HISTORIC AND DESIGN REVIEW COMMISSION

September 02, 2020

HDRC CASE NO: 2020-366
ADDRESS: 321 N HACKBERRY ST
LEGAL DESCRIPTION: NCB 583 BLK 8 LOT 11
ZONING: IDZ-1, H
CITY COUNCIL DIST.: 2
DISTRICT: Dignowity Hill Historic District
APPLICANT: John Barr/321 HACKBERRY LLC
OWNER: John Barr/321 HACKBERRY LLC
TYPE OF WORK: Amend previously approved windows, amend previously approved roofing materials
APPLICATION RECEIVED: August 14, 2020
60-DAY REVIEW: Not applicable due to City Council Emergency Orders
CASE MANAGER: Edward Hall
REQUEST:

WINDOW DETAIL

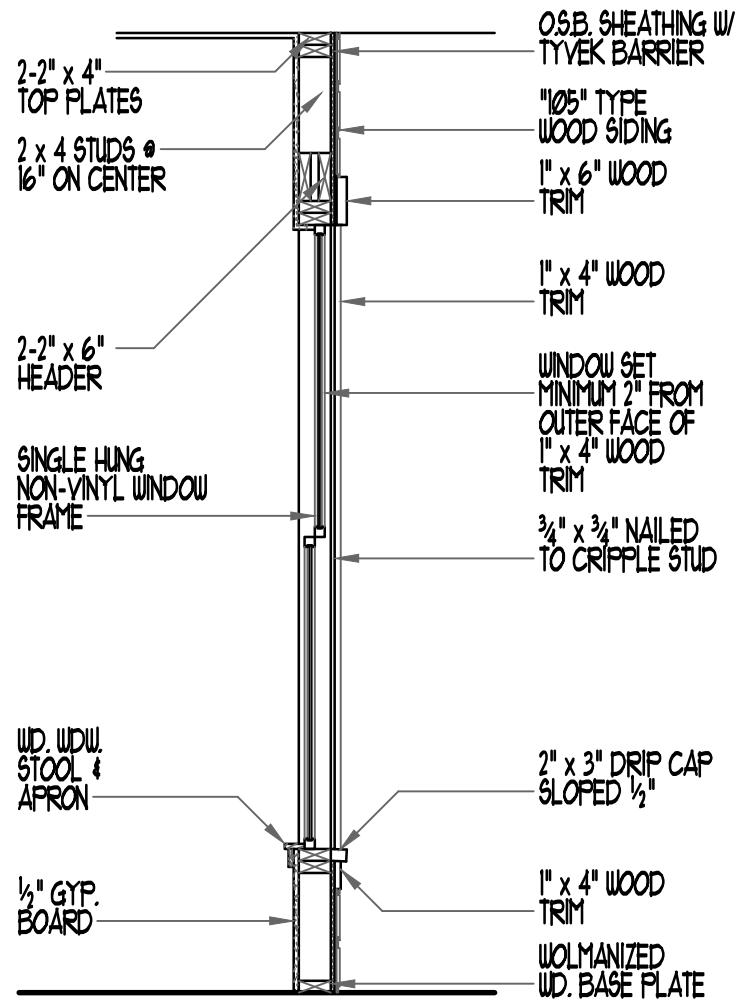
- d. **WINDOWS** – The applicant previously received approval to install wood or aluminum clad wood windows that met staff's standard specifications for windows in new construction. At that time, the applicant has proposed to install an aluminum window that does not meet staff's standard specifications for windows in new construction. Staff performed a site visit on August 13, 2020, to view a mock up of the proposed window and found that the meeting rails, top and bottom rails, frame color, and trim profiles were not consistent with staff's standard specifications for windows in new construction. Since that time, the applicant has noted the installation of dark colored frames.

- e. **WINDOWS (Trim)** – The applicant has proposed to install 2x4 framing lumber as trim. Staff's standard specifications for windows in new constructions notes that window trim must feature traditional dimensions. Staff finds that 2x4 framing lumber is not a traditional lumber member for trim. A traditional application, such as a 1x4 should be used instead.

- f. **WINDOW DOCUMENTS** – At this time, the applicant has submitted neither manufacturer's specifications nor a detailed wall section of the proposed windows and their installation.

1. Staff recommends approval of item #1, an amendment from a standing seam metal roof to an asphalt shingle roof as submitted, based on finding c.
2. Staff does not recommend approval of item #2, an amendment to a window that does not meet staff's standard specifications for windows in new construction. Staff recommends the applicant install a window that meets staff's standard specifications, as previously approved. Furthermore, staff recommends that the proposed 2x4 trim be eliminated and that traditional trim be incorporated into the design, as noted in finding e and in the applicable citations.
